1958 Agreement:**consideration of draft amendments to existing****UN Regulations submitted by GRE****Proposal for a new 03 series of amendments to UN
Regulation No. 53 (Installation of lighting and light-signalling
devices for L₃ vehicles)****Submitted by the Working Party on Lighting and Light-Signalling***

03 series of amendments to UN Regulation No. 53 (Installation of lighting and light-signalling devices for L₃ vehicles)

Model A

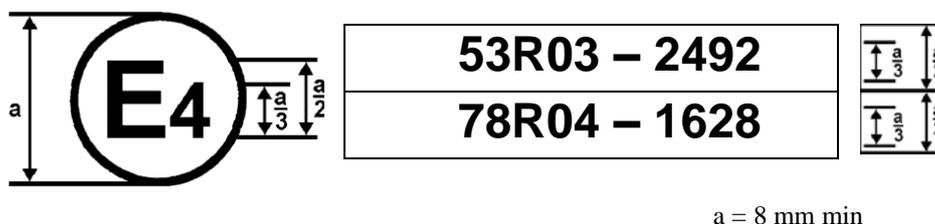
Annex 2, amend to read:

The above approval mark affixed to a motorcycle shows that the vehicle type concerned has, with regard to the installation of lighting and light-signalling devices, been approved in the Netherlands (E 4), pursuant to UN Regulation No. 53, as amended by the 03 series of amendments. The approval number indicates that the approval was granted in accordance with the requirements of UN Regulation No. 53.
